AXIS OS Portal

Breaking changes

Below is a list of changes planned for the first version of AXIS OS 13, scheduled for release in September 2026.

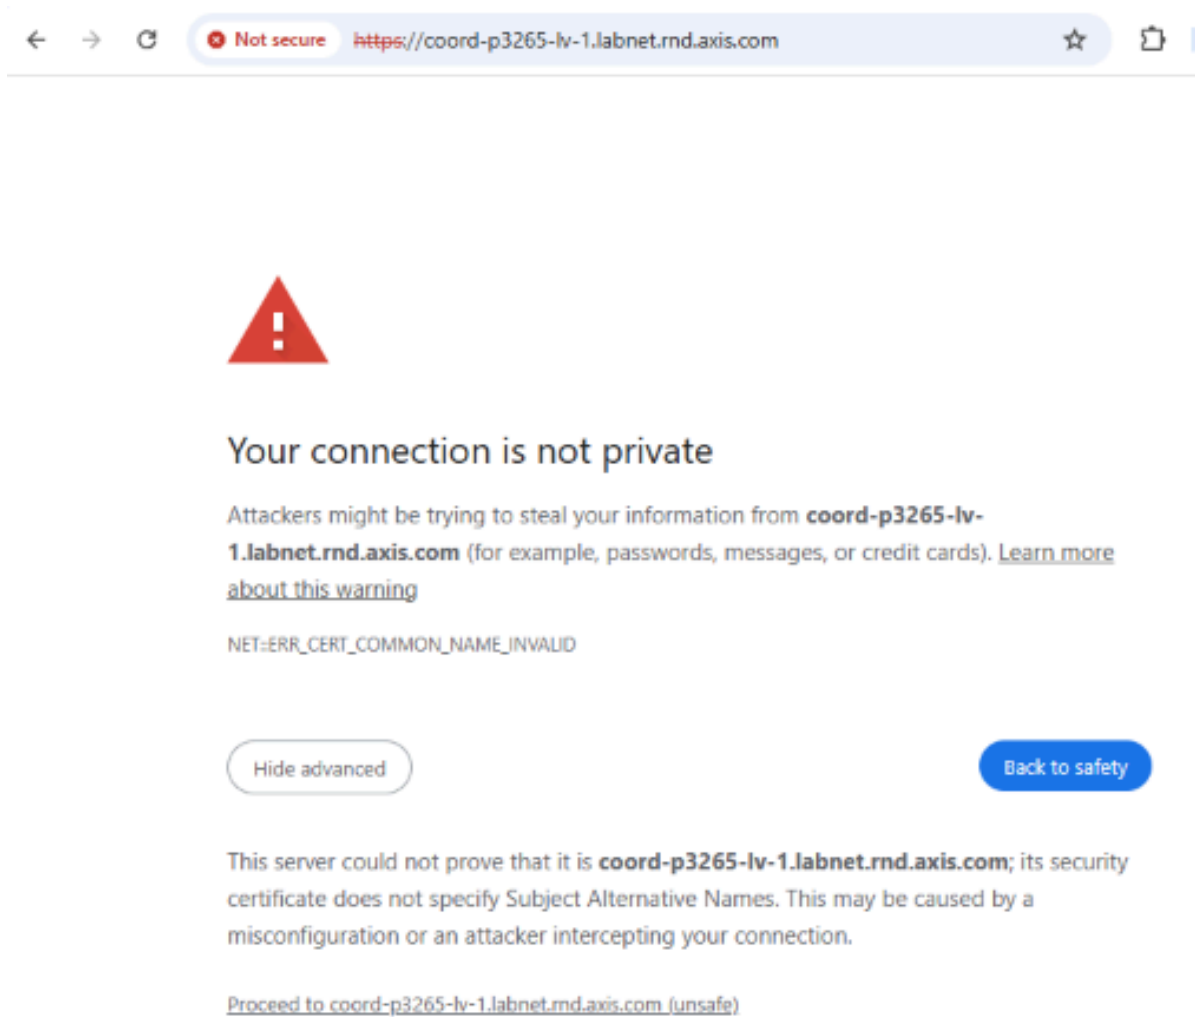
The impacts: By default, network connections to the device will only be allowed on HTTPS port 443. To use HTTP port 80, you must enable it first; otherwise, no network connection can be established. Even with a secure HTTPS connection, your browser might still show a warning due to issues validating the certificate. This is expected behavior, as IoT device certificates aren't compatible with most browsers. When accessing the Axis device's web interface via HTTPS, your web browser might display a warning message. This happens because the browser checks the certificate's information against the device's URL, which doesn't match due to the default certificate used in Axis devices. Device manufacturers can't resolve this issue, as it's inherent to how browsers verify certificates.

Reason for change: To increase the overall device security following the secure-by-default strategy and reduce the hardening guide configuration steps for the user.

Affected VAPIX parameters:

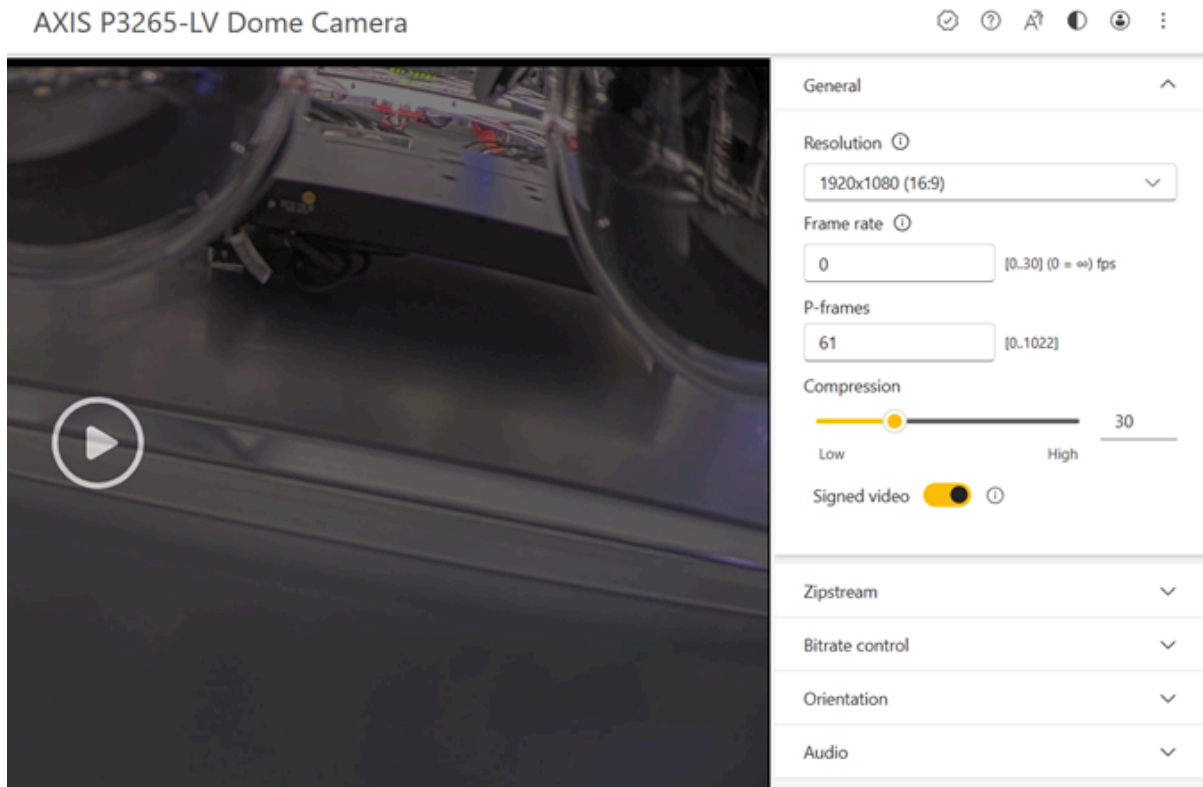
The default values will change from:

System.BoaGroupPolicy.admin=both
 System.BoaGroupPolicy.operator=both
 System.BoaGroupPolicy.viewer=both
 To:

- Basic authentication for HTTPS connections**

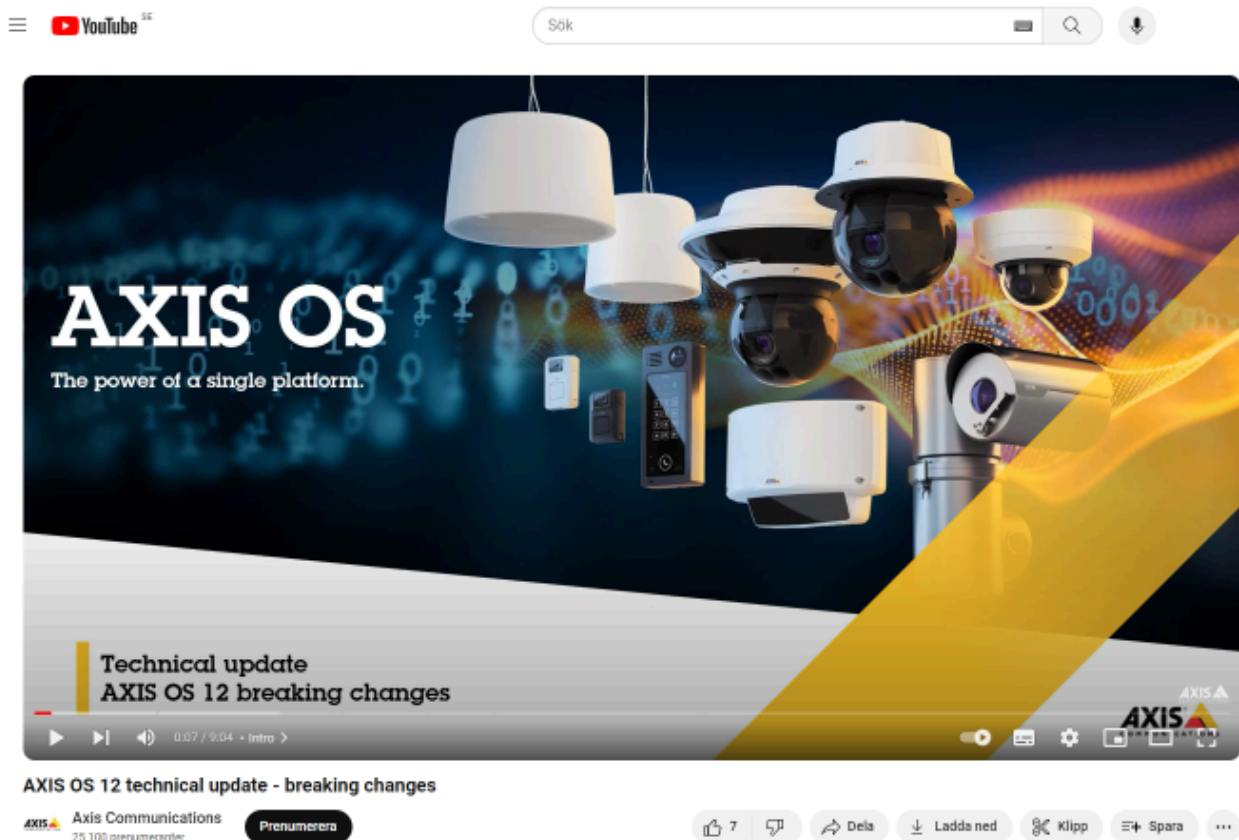
Axis devices perform digest authentication when serving both HTTP and HTTPS connections. Since HTTPS connections are preferred for increased security, Axis will change the default behavior so that basic

authentication is used for HTTPS connections only by introducing a new authentication policy mode called "Recommended". The authentication policy for HTTP & the RTSP server will not change in this mode. More information about the authentication policy can be found in the *VAPIX Library*. Using basic authentication in HTTPS connections is IT-industry standard and allows Axis devices to operate in a well-defined and common practice as well. Digest authentication will still be kept for serving for unencrypted HTTP connections. Using HTTPS only is the recommended operational mode for Axis devices.

Why is this change introduced? To follow the IT-industry standard.

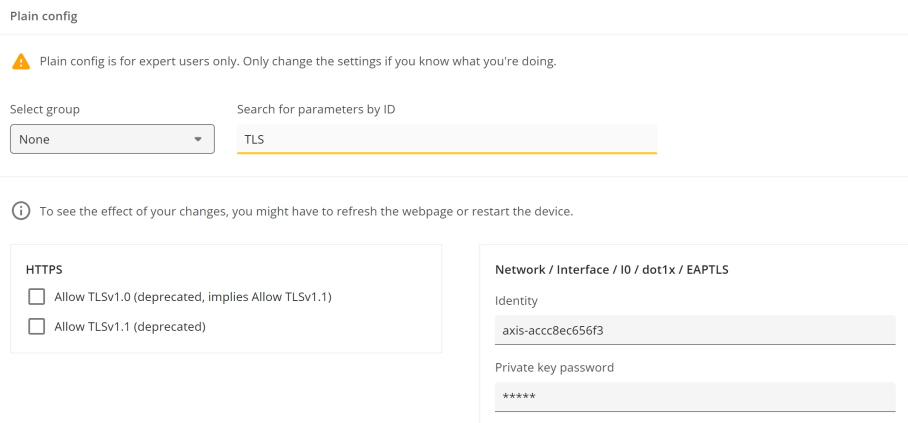
connections. Axis will completely remove TLS 1.0/1.1 versions for HTTPS connections to increase overall security and prevent users from accidentally enabling these protocol versions.
 VAPIX API Parameter: root.HTTPS.AllowTLS1 and root.HTTPS.AllowTLS11

Why is this change introduced? It is obsolete, and keeping it might be a security threat.
How can it affect me? If you have third party software using TLS 1.0/1.1 HTTPS connections, it will not work correctly with AXIS OS 12.0 or higher.

- **Removal of ACAP Computer Vision SDK support**

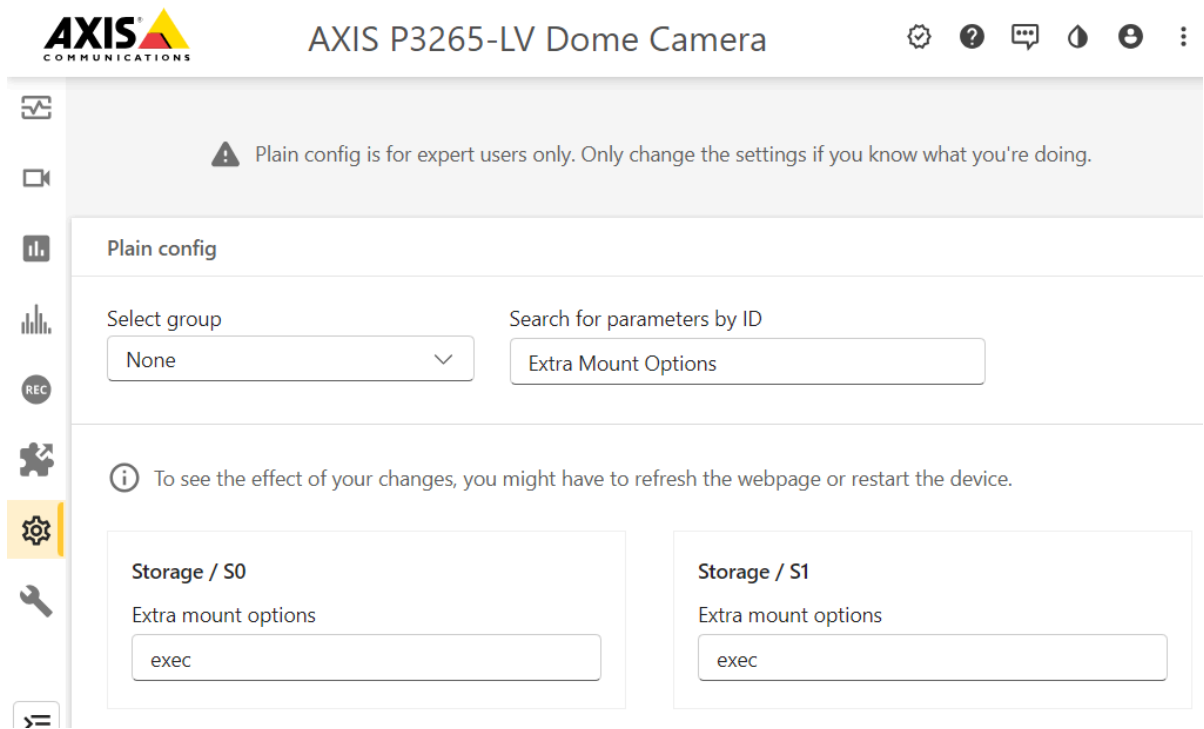
The ability to enable ACAP Computer Vision SDK support will be removed for the listed products because they only have 1 GB of memory.

Applies to: AXIS D2210-VE, AXIS M3215-LVE, AXIS M3216-LVE, AXIS M5526-E, AXIS P1465-LE, AXIS P1465-LE-3, AXIS P3265-LV/-LVE/-V and AXIS P3265-LVE-3

Why is this change introduced? Running the Computer Vision SDK on the product will consume too much memory and may render the product inoperable.
